CPED STAFF REPORT
Prepared for the City Planning Commission

CPC Agenda Item #4
March 3, 2014
BZZ-6579

Property Location: 5336 Lyndale Avenue South
Project Name: 5336 Lyndale Avenue South
Prepared By: [Mei-Ling Anderson](#), City Planner, (612) 673-5342
Applicant: Bill Graham
Project Contact: Bruce Hellier
Request: To construct a new three-story, mixed-use building with four dwelling units.
Required Applications:

C.1

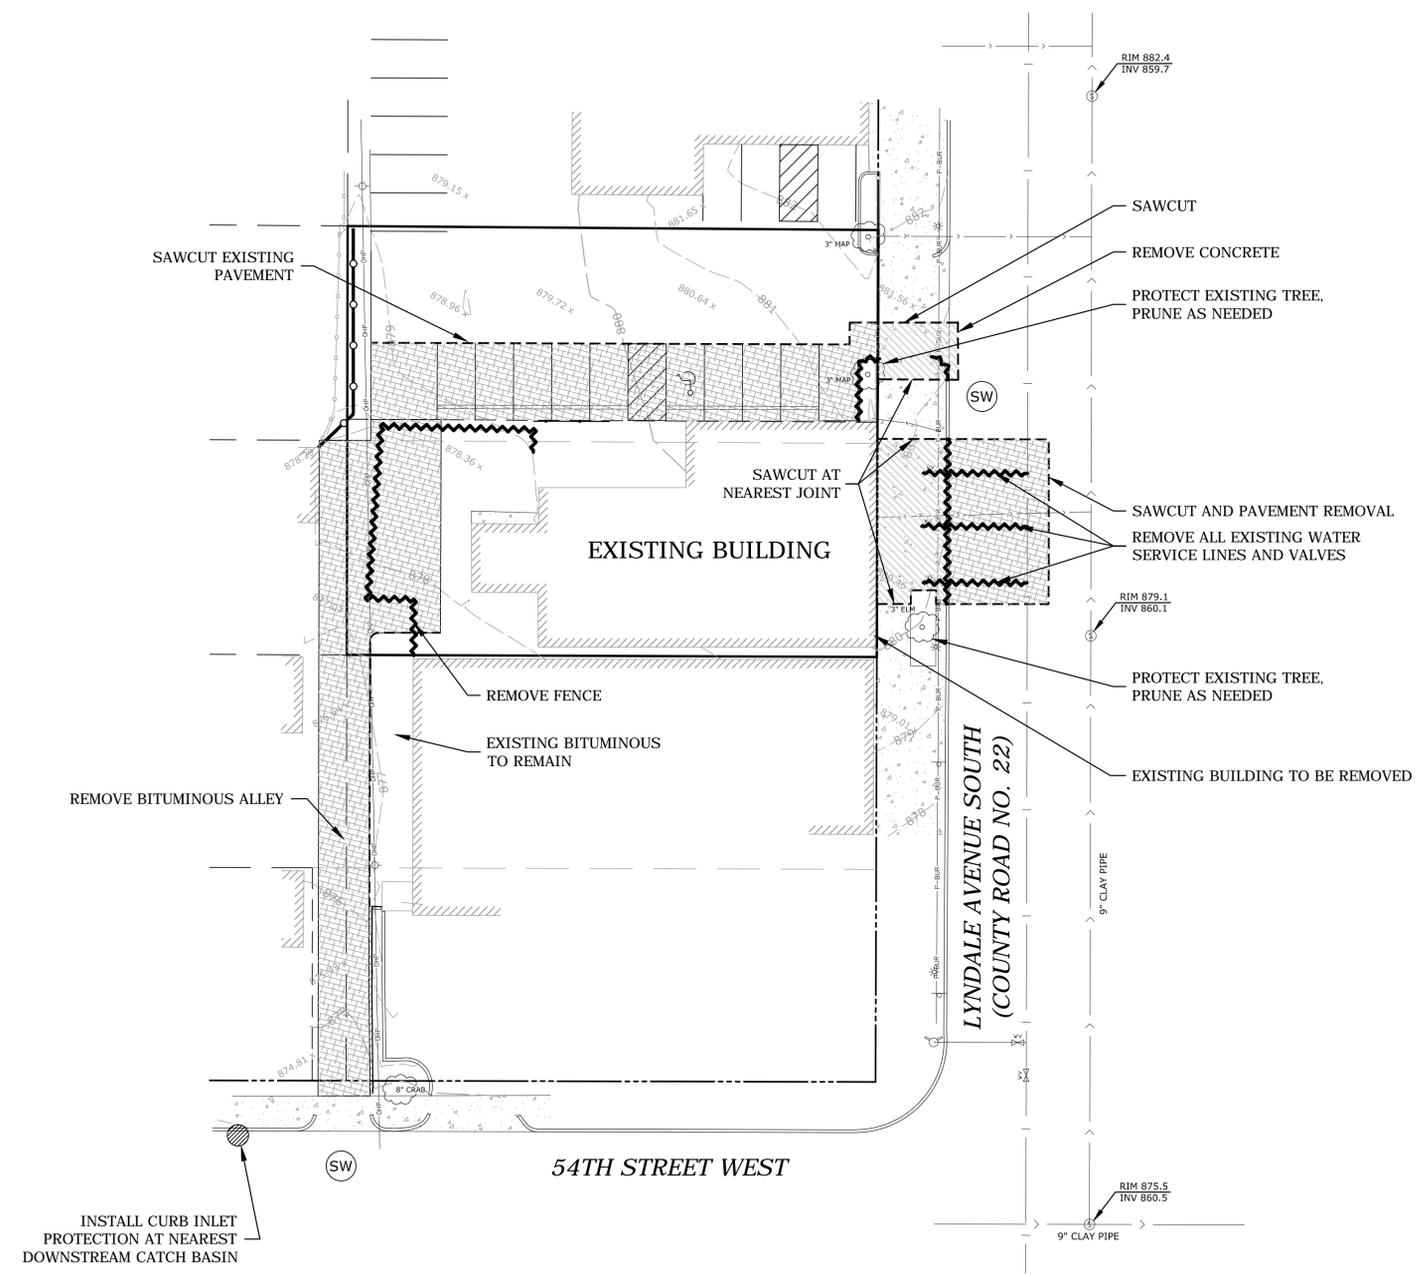
- Note to the Applicant: The submitted plan combines most of the civil engineering items into a single sheet (Sheet C.1). It is recommended that a separate sheet be provided for demolition and erosion control items.

EAST ELEVATION LYNDALE AVE. SIDE
1/8"=1'-0"

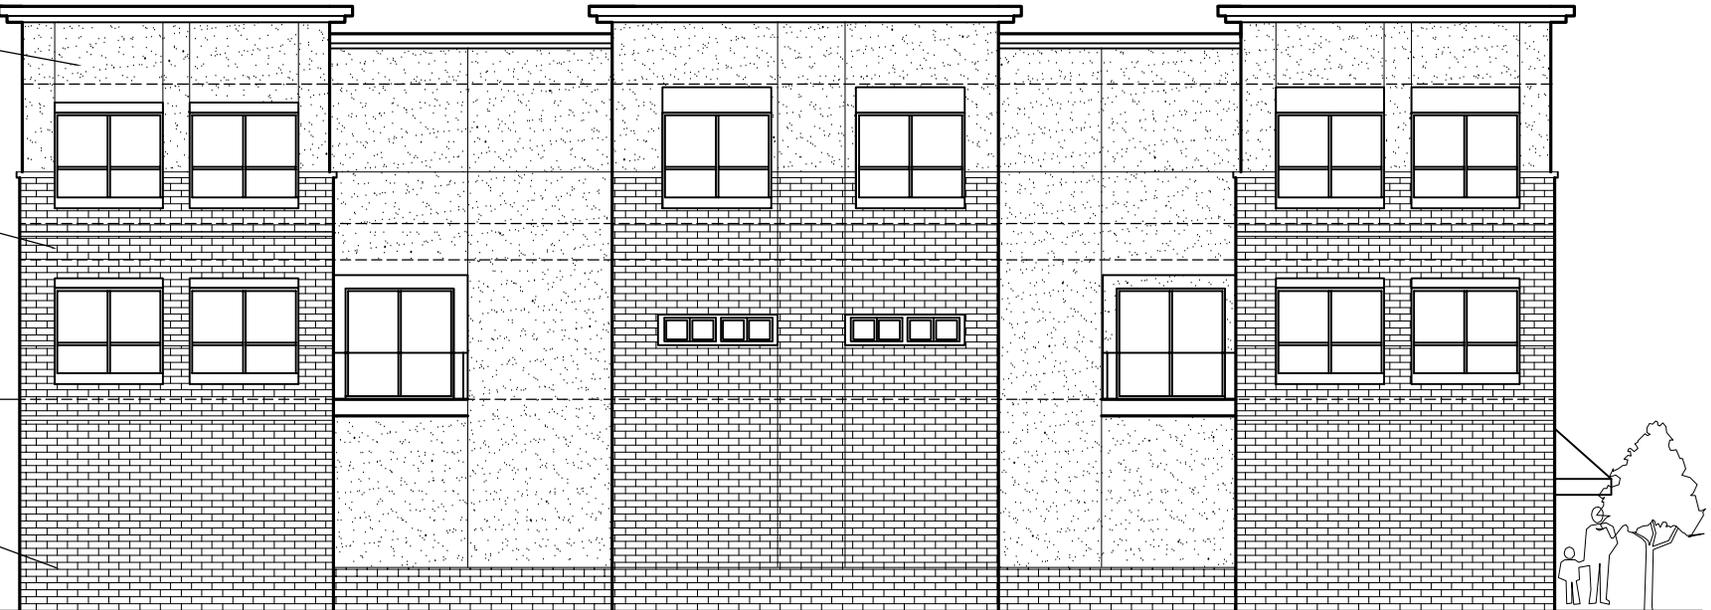
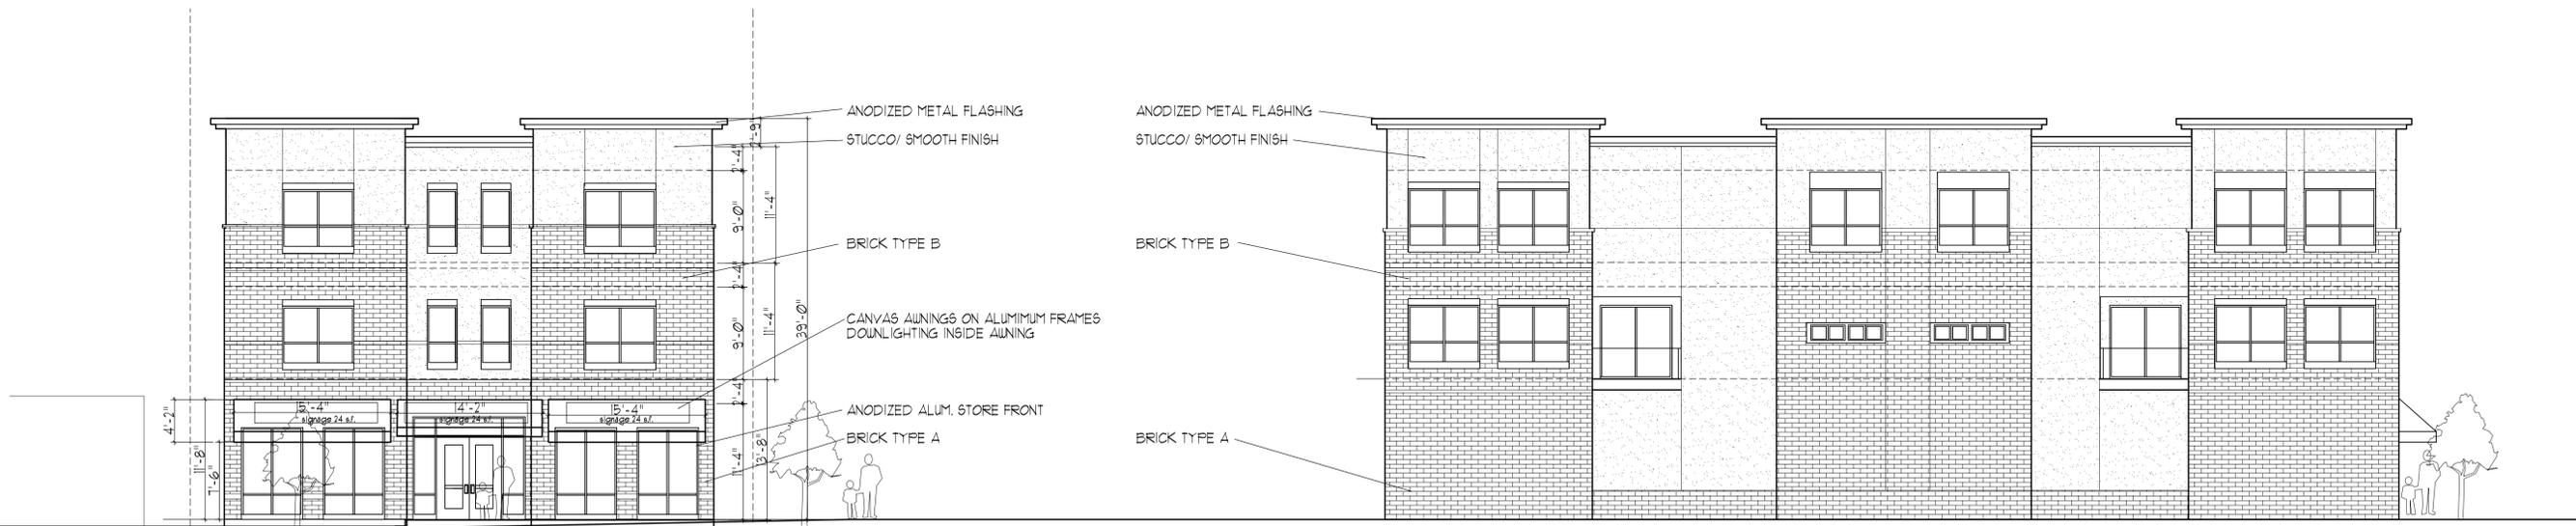
- Plain face concrete block is not proposed as an exterior material.
- The proposed principal entrance would be clearly defined with canvas awnings with aluminum frames. A second principal entrance is proposed on the north elevation but is not clearly defined and requires alternative compliance.

- The window requirement affects the elevation facing Lyndale Avenue South. The requirements for windows are being met. See **Table I**.
- The entire ground floor of the building facing Lyndale Avenue South would contain active functions.

3. All signs require a separate sign permit from CPED.
4. The applicant shall work with CPED staff to provide additional ground-level windows and one awning over the building entrance on the north elevation of the building.
